Gables Station

COMPREHENSIVE PLAN MAP AMENDMENT
ZONING MAP AMENDMENT
ZONING CODE TEXT AMENDMENT
PLANNED AREA DEVELOPMENT
MIXED USE SITE PLAN

215 AND 251 S. DIXIE HIGHWAY
CITY COMMISSION 2ND READING
JULY 26, 2016

COMMISSION 1ST READING REQUESTS:

#1: BUILDING HEIGHT

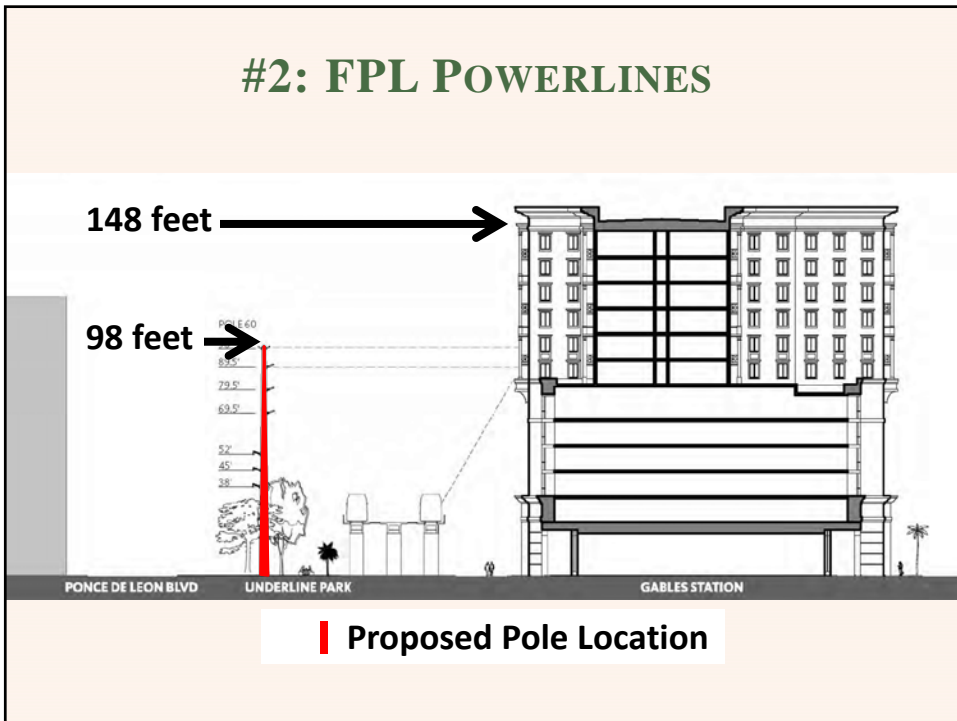
1. Reduce building height while maintaining the same percentage of open space.
2. Show FPL powerline locations in drawings of the Underline.
3. Finalize the trolley contribution proposal.
4. Confirm the timing of the Underline improvements.
5. Update the Traffic Impact Study.
6. Provide the Art in Public Places concept.
7. Update site plan to include more landscaping at the ground level.

The request is justified because the Gables Station project is located on the only site in Coral Gables that:

1. Directly abuts the Metrorail right-of-way, and
2. Is targeted for Mixed-Use redevelopment, and
3. Is of a sufficient size to accommodate a Mixed-Use project.

Therefore, approval of additional height at this site does not create a precedent for other sites along US1.

Due to the specific site characteristics of this Mixed-Use redevelopment site adjacent to Metrorail and its associated noise and visual impacts, **Staff recommends approval of the project at the height proposed by the Applicant: 160 feet for Building A and 148 feet for Buildings B and C.** The proposed height is less than the maximum height allowed in the City (190'6").
